CAPITAL PROJECTS DIVISION Addendum No. 1 Date: 09-09-2025 For: Drawings and Specifications For: CONTRACT NO. PRJ000371 SOUTHERN POLICE DISTRICT INTERIOR RENOVATIONS FOR THE MAYOR AND CITY COUNCIL OF BALTIMORE TO THE BIDDERS: THIS ADDENDUM IS HEREBY MADE A PART OF THE CONTRACT DOCUMENTS ON WHICH THE CONTRACT WILL BE BASED, AND IS ISSUED TO MODIFY, EXPLAIN AND/OR CORRECT THE ORIGINAL DRAWINGS AND SPECIFICATIONS. PLEASE ACKNOWLEDGE THIS ADDENDUM ON THE BID OR PROPOSAL PAGE WHERE INDICATED. **APPROVED: DESIGN PROJECT MANAGER** CONSTRUCTION PROJECT SUPERVISOR MalinMendonca **ENGINEER SUPERVISOR** Christopher A. Hepler **DIVISION CHIEF**

RESPONSES TO CONTRACTOR WRITTEN QUESTIONS SUBMITTED

CONTRACT NUMBER PRJ000371 SOUTHERN POLICE DISTRICT INTERIOR RENOVATIONS

M201

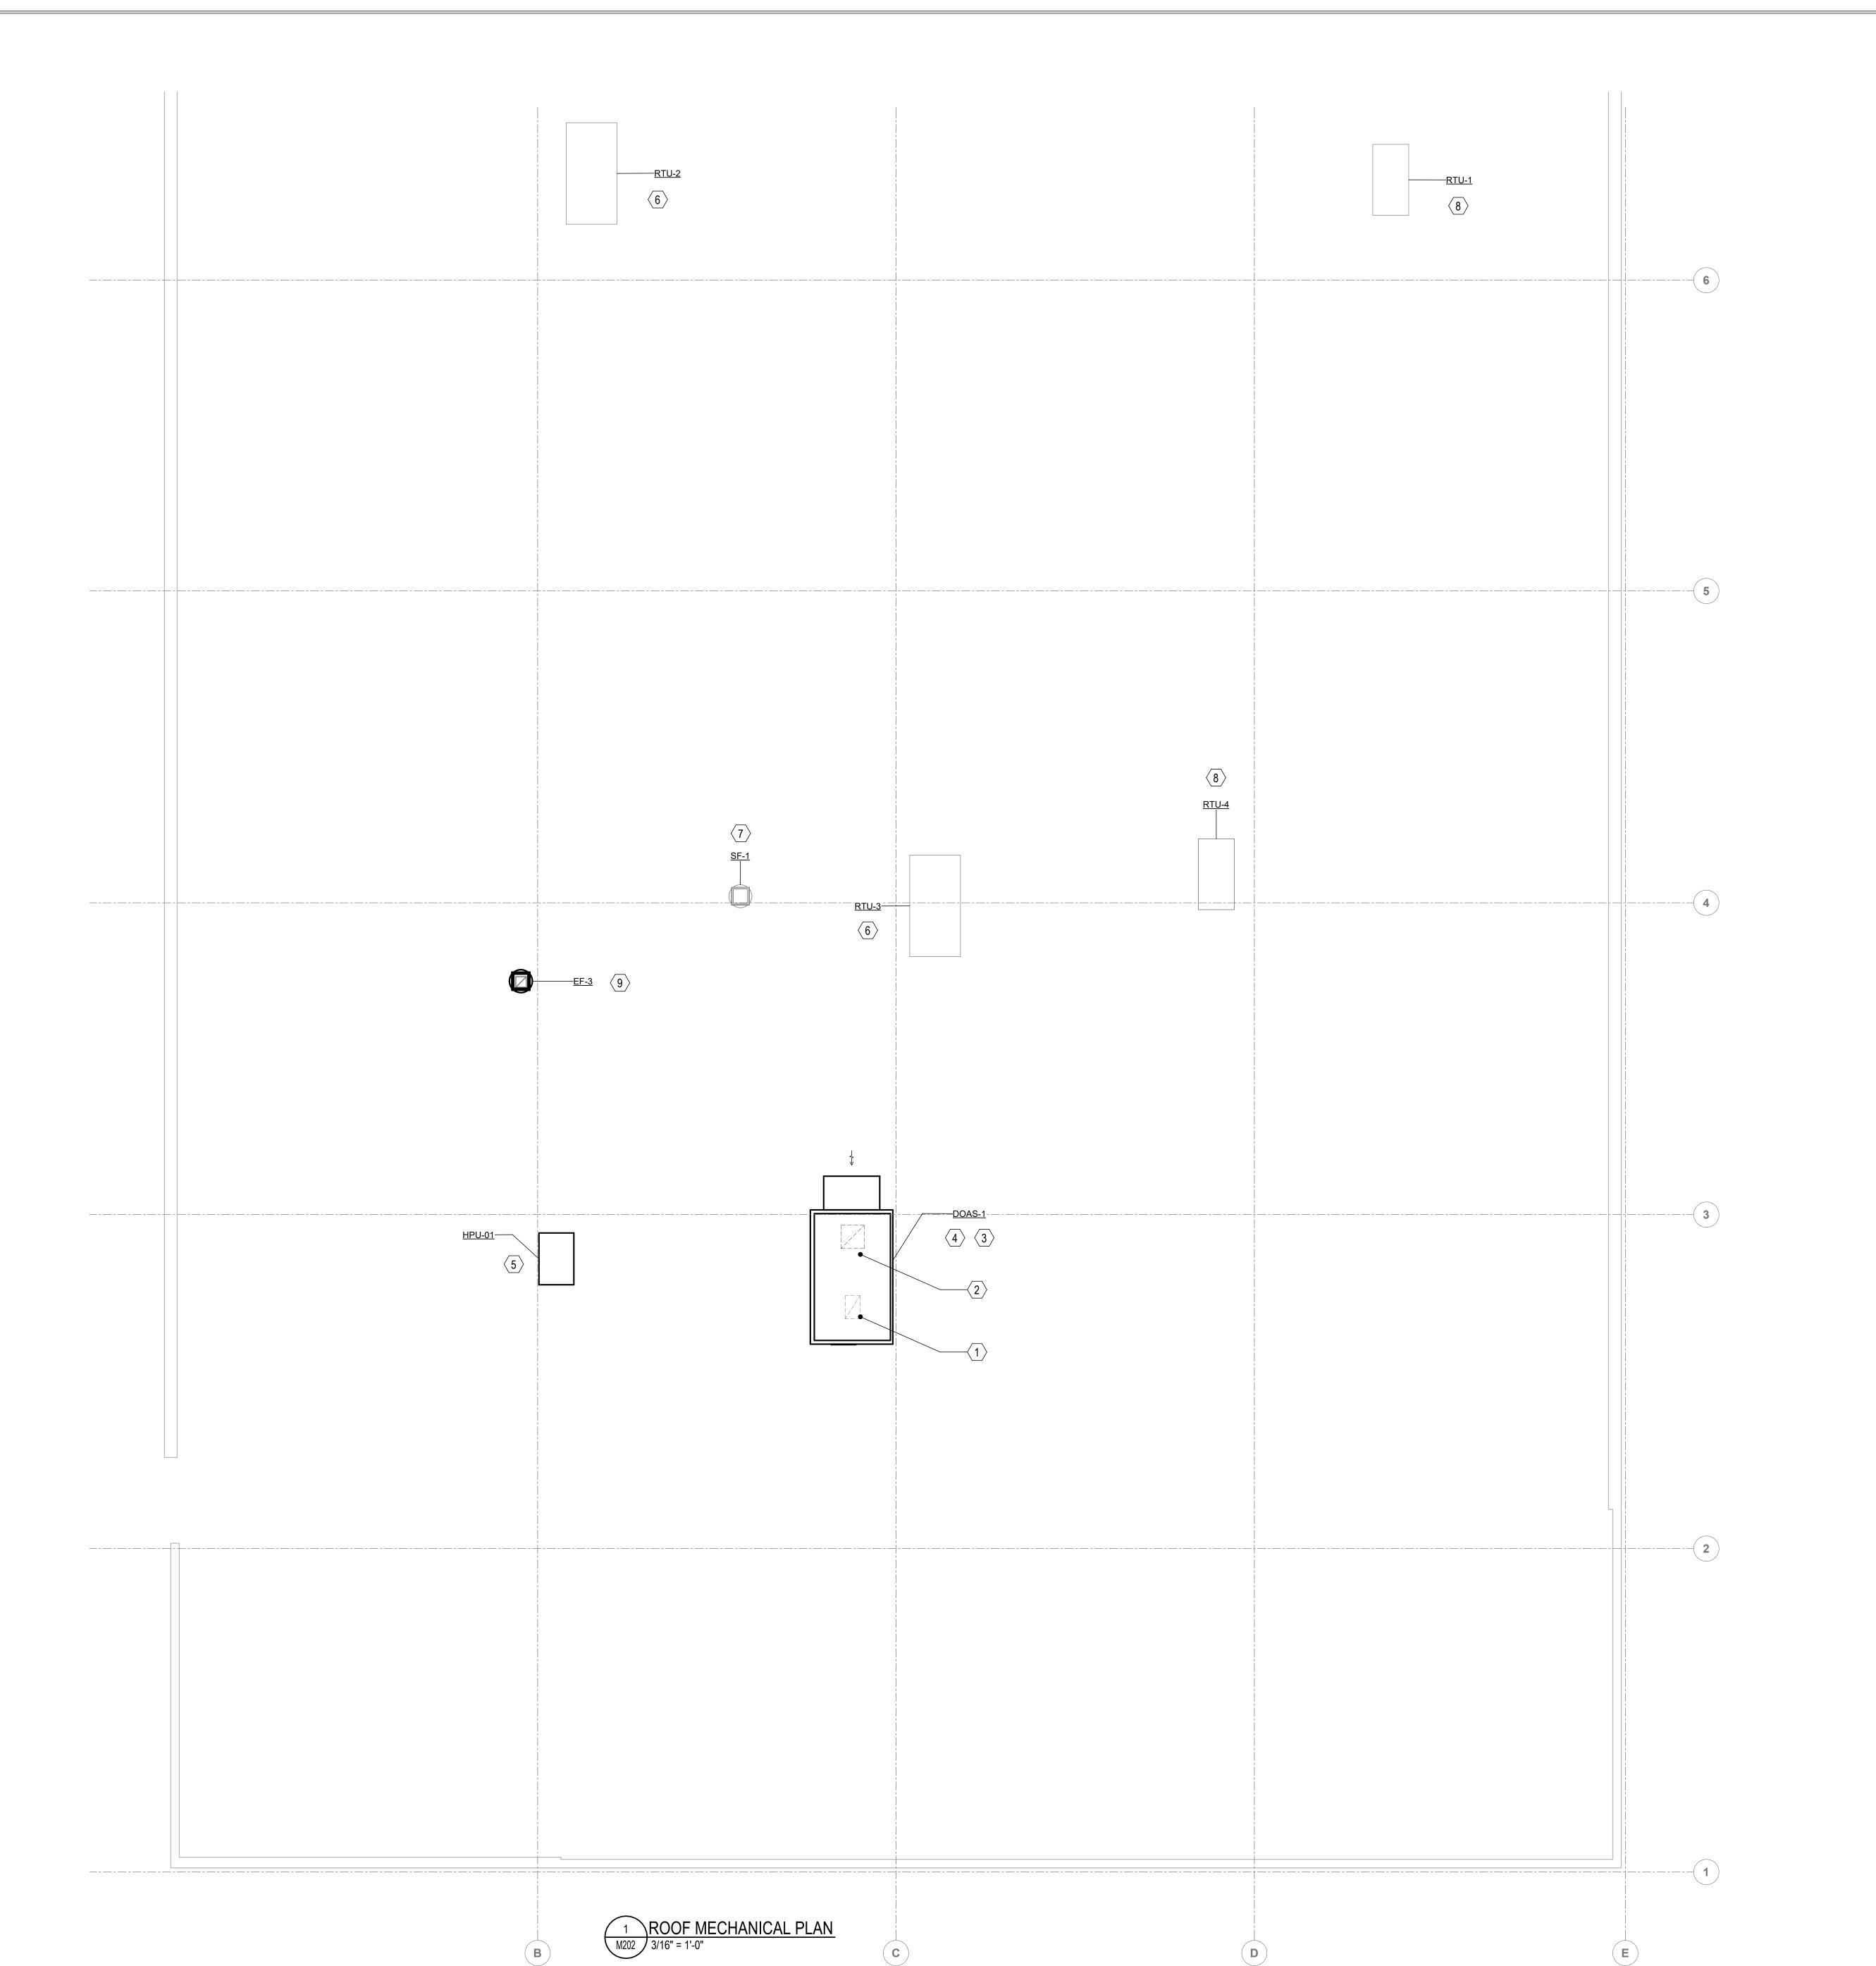
38.[M201, M202] Please provide routing for refrigerant piping from Condensing Unit to Branch Selectors, and from Branch Selectors to Indoor Fan Coil Units.

39.[M201] Please provide routing and termination for ac condensate piping to Branch Selectors and Indoor Fan Coil Units.

42.[M201] Please revise the drawing to include an architectural floorplan so wall penetrations can be accounted for.

Response: Refrigerant pipe routing will be provided from the outdoor condensing unit to the Branch selector to the Fan coil units.

Response: Condensate drain disposal is accounted for per Mechanical New Work Keynote 4. Condensate drainpipe is to tie into nearest existing storm, coordinated in field.

Response: Revised MEP drawings with applicable backgrounds are now available.

SHEET M202

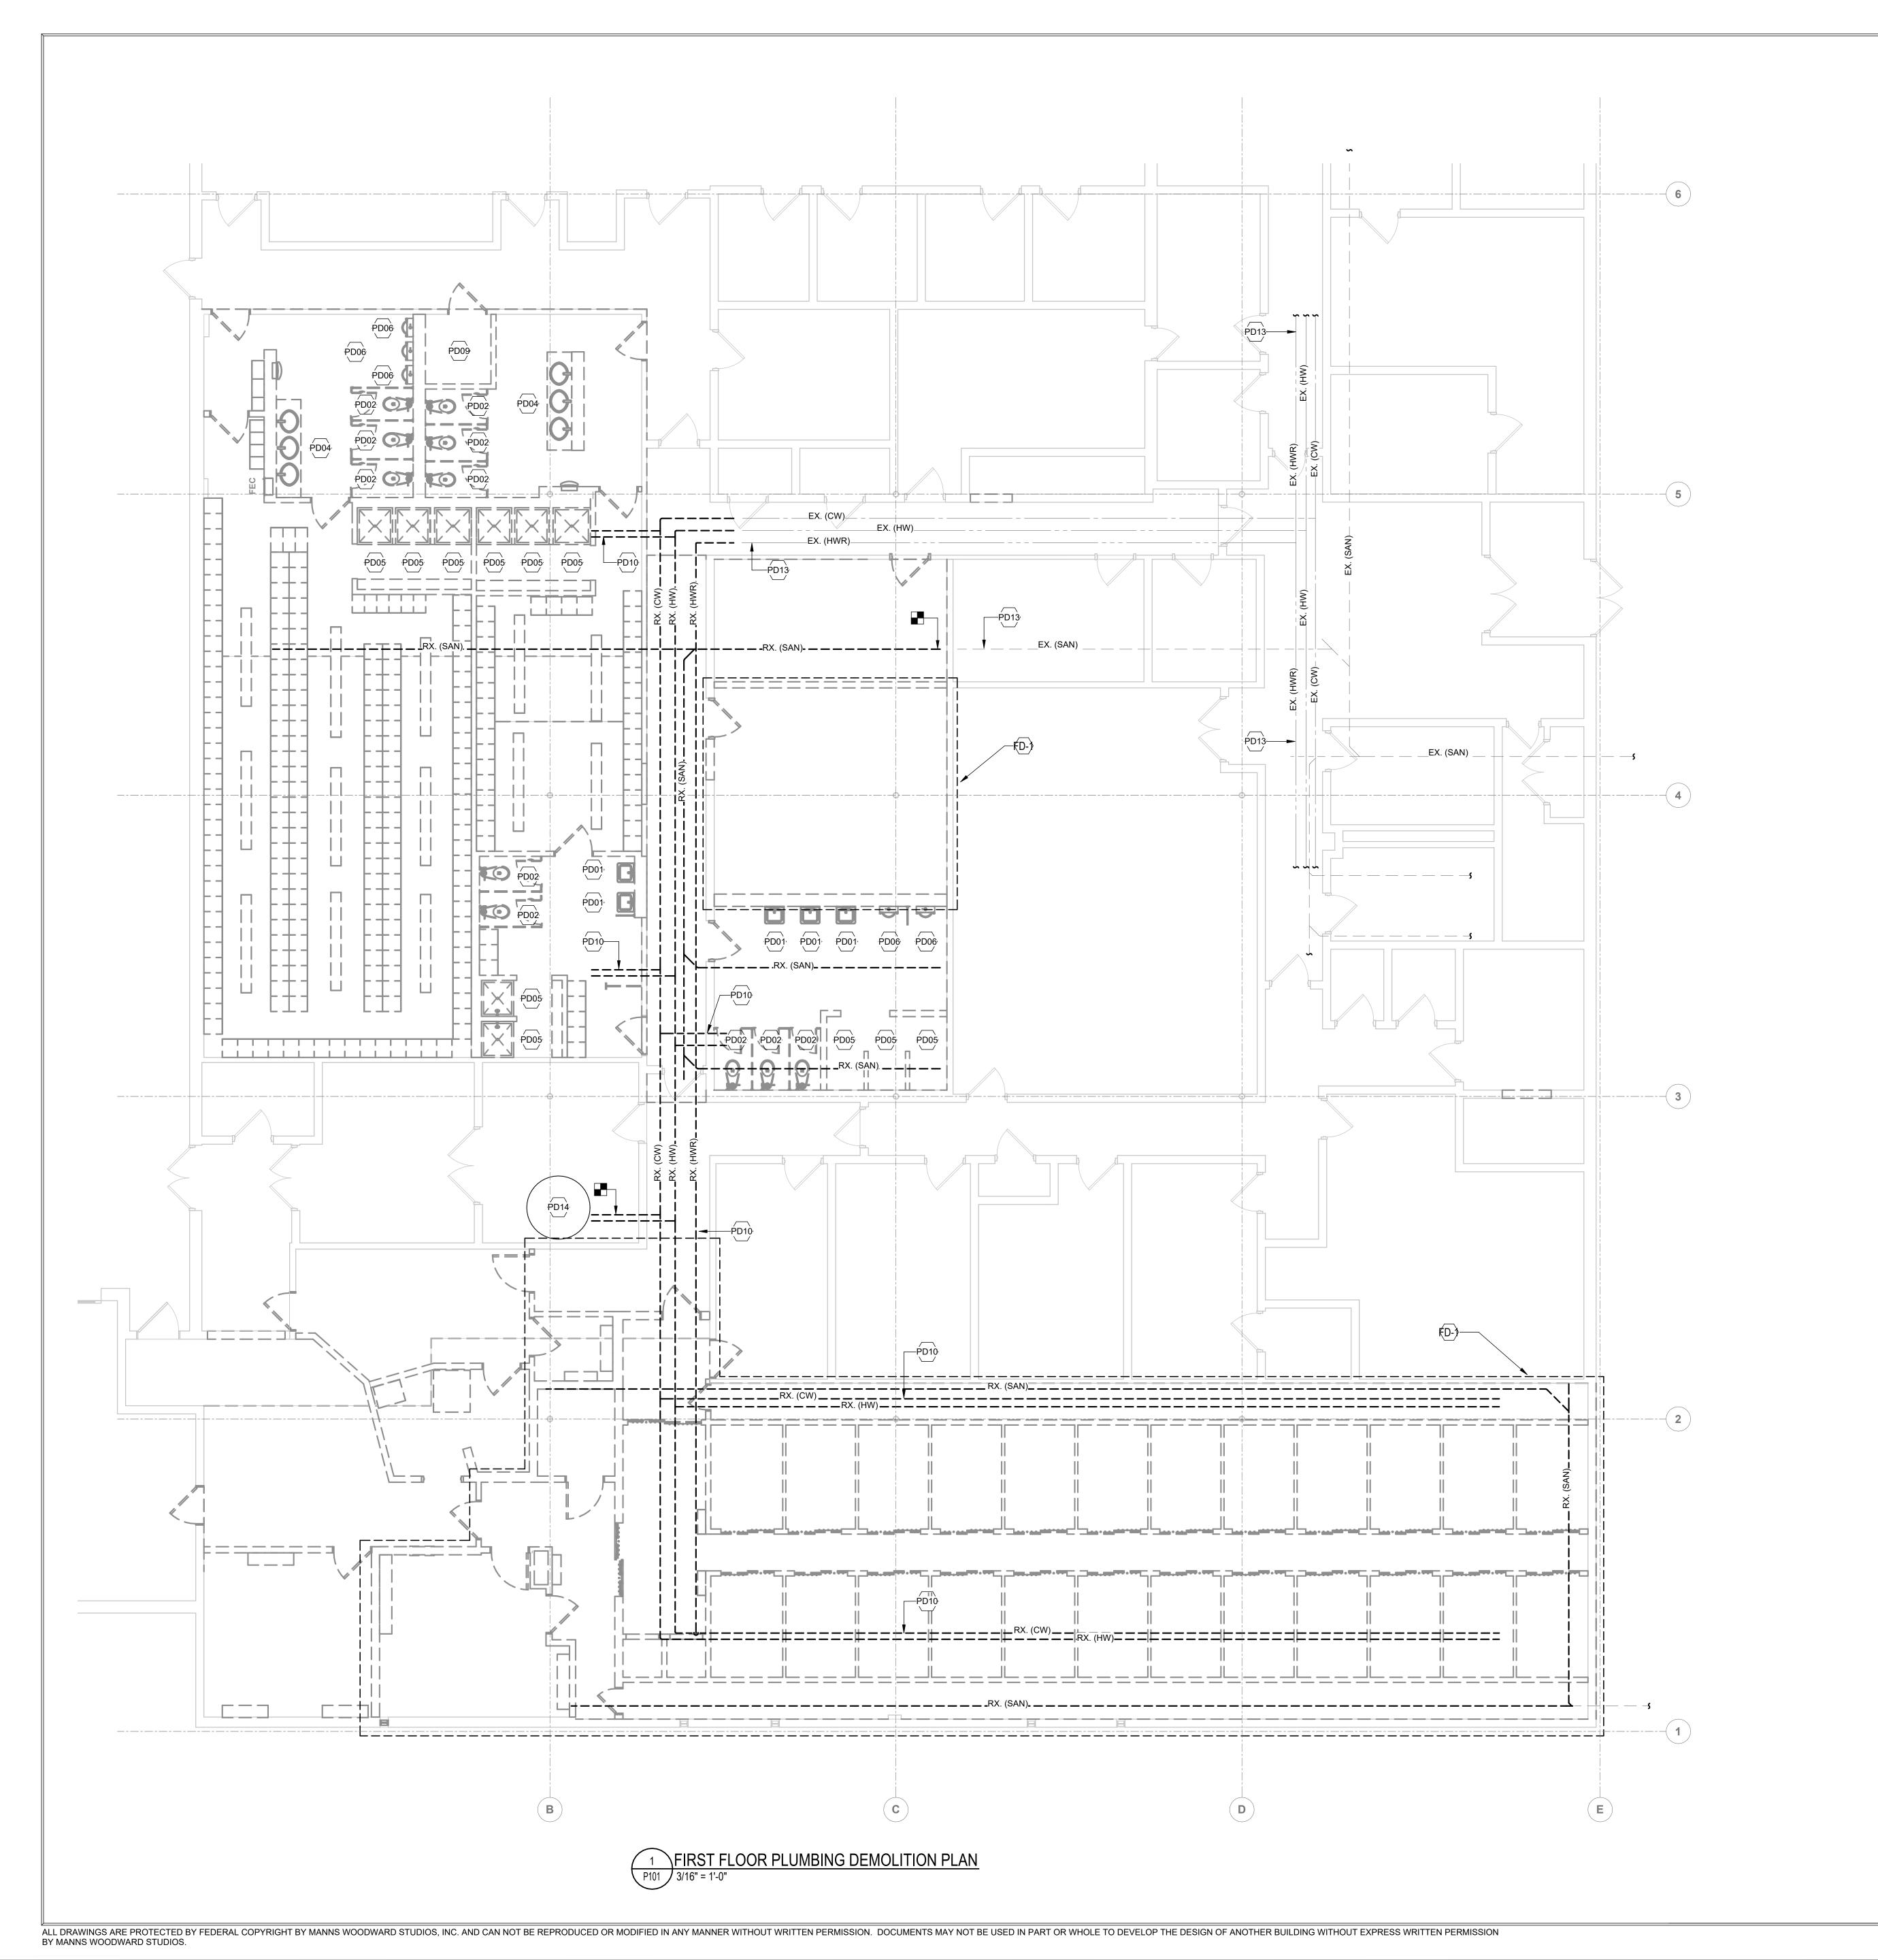
40. [M202] Please provide locations for roof penetration for refrigerant piping to CU-1.

Response: Contractor to locate final penetrations for equipment piping.
